Access Compliance Report

Public Rights-of-Way

Intersection ID: 47581	Main Street: CHAPECLANE_RD	Cross Street: ROCK_ISLAND_RD	Location: SW
ADA ID: 6E529192681A	Ramp Type: PerpDiag	Initial Pass/Fail: Fail	Overall Compliance: No
			Severity Score: 21.25

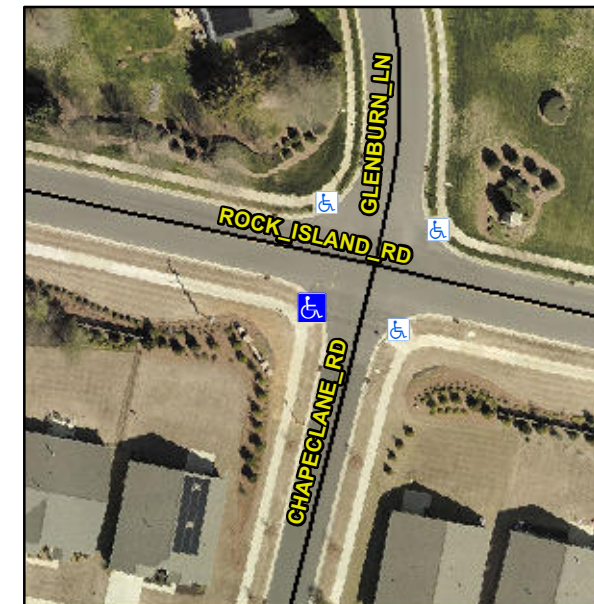
Not Found, R304.5.1, R304.5.3

Compliance	Description	Data	Compliance	Description	Data
N/A	Ramp Length (in)	97.0	Yes	Ramp Slope (%)	8.0
No	Ramp Width (in)	45.0	No	Ramp XSlope (%)	6.6
N/A	Flare Type LT	N/A	N/A	Flare Type RT	N/A
N/A	Flare Slope LT (%)	N/A	N/A	Flare Slope RT (%)	N/A
N/A	Flare Traversable LT?	N/A	N/A	Flare Traversable RT?	N/A
N/A	Landing Length (in)	N/A	N/A	DWS Provided?	N/A
N/A	Landing Width (in)	N/A	N/A	DWS Contrast?	N/A
N/A	Landing Slope (%)	N/A	N/A	DWS Length (in)	N/A
N/A	Landing X Slope (%)	N/A	N/A	DWS Full Width?	N/A
N/A	Landing Curb? (Y/N)	N/A	N/A	DWS Offset (in)	N/A
N/A	Shared Landing?	N/A			
N/A	Gutter Ponding?	N/A	N/A	Gutter Slope (%)	N/A
N/A	Gutter Lip Ht (in)	N/A	N/A	Gutter X Slope (%)	N/A
N/A	Painted X Walk1?	No	N/A	Painted X Walk2?	No
	X Walk 1 Direction	To SE		X Walk 2 Direction	To NE
N/A	X Walk 1 Width (in)	N/A	N/A	X Walk 2 Width (in)	N/A
	X Walk 1 Slope (%)	1.5		X Walk 2 Slope (%)	6.2
	X Walk 1 X Slope (%)	5.1		X Walk 2 X Slope (%)	2.2

Remove & Replace Curb Ramp With Two New Directional Ramps or Equivalent.
